## Global Nuclear Fuel

FLN-2004-026

Subject: **GESTAR II Amendment 28 Revision 1, Misloaded Fuel Bundle Event  
Licensing Basis Change to Comply with Standard Review Plan 15.4.7**

GNF is hereby submitting this letter to revise the Reference 1 letter. An error was discovered in the execution of the code that analyzes the radiological offsite dose consequences; therefore, the only change being made is to correct the tables and figures contained in Attachment B, and any conclusions drawn from these tables and figures. These changes, in Appendices A and B only, in this electronic version was printed with all revision marks activated. Original text that has been deleted is marked as a ~~strike through~~ and new text is in color. For completeness, the entire package is being resubmitted in its original form. The page changes to GESTAR II are unaffected.

**Figure B-1 Scenario 1 Dose with respect to Dispersion Coefficient**

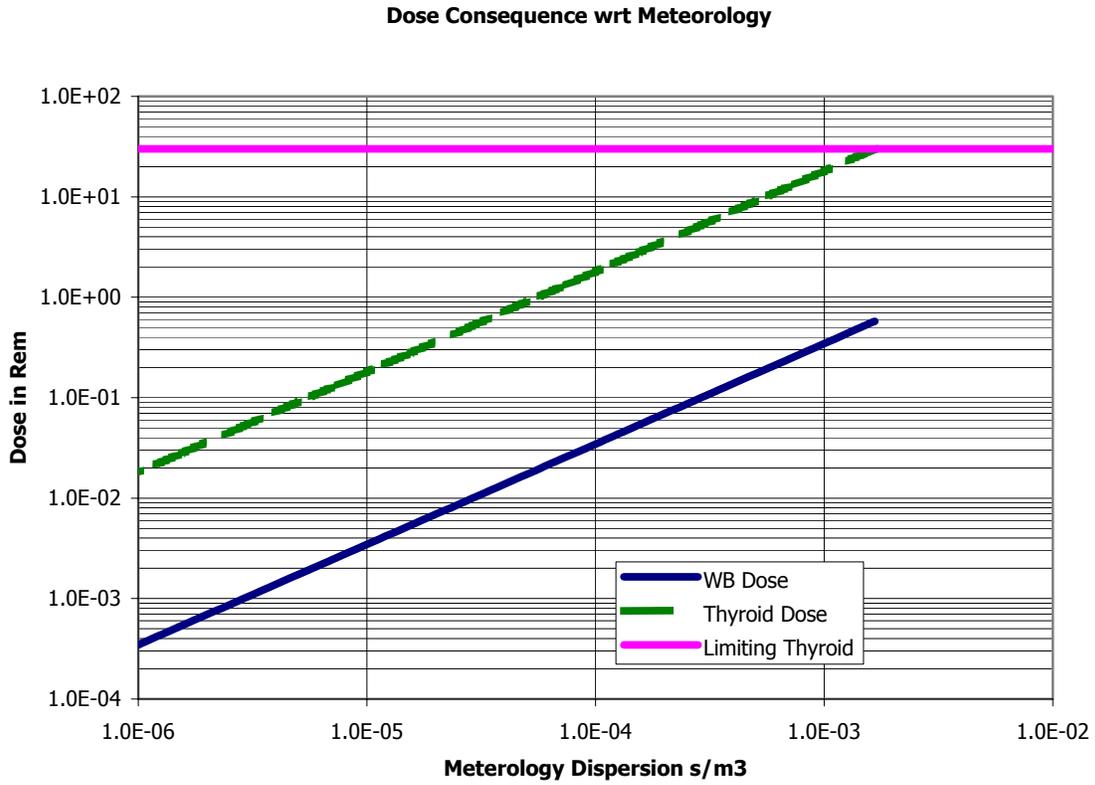
~~The Chi/Q dispersion limit is back calculated from the 30 Rem thyroid dose based on the 2-hour Chi/Q at the EAB for a ground level release (though the total release integrated to 24 hours is used in the dose calculation). Doses are calculated using an enveloping value of  $2.5 \times 10^{-3}$  sec/m<sup>3</sup> for the 2-hour Chi/Q at the EAB for a ground level release. The resultant Chi/Q dispersion~~

value was found to be  $1.67 \times 10^{-3} \text{ s/m}^3$ , which bounds BWRs surveyed in Reference 9. Note that the curve given in Figure B-1 is conservative in that the dispersion coefficient is constant over the 24 hour period of release and does not provide for reductions in dose for longer term dispersion factors. ~~This value was determined in past studies to be in excess of all such values provided by BWR owners (Reference 9) in response to a request for site specific data. The 2-hour doses obtained with the Chi/Q value were 4.6 Rem to the thyroid and 0.31 Rem whole-body (0.22 Rem TEDE). Since the calculated dose is directly proportional to the value of Chi/Q, doses for any other Chi/Q value may be scaled directly from these results and will be lower for any site when time variations in meteorology are accounted for. The relationships between calculated thyroid and whole-body doses and Chi/Q are shown in Figure B-1. These curves may be used to read offsite doses corresponding to a site specific Chi/Q.~~
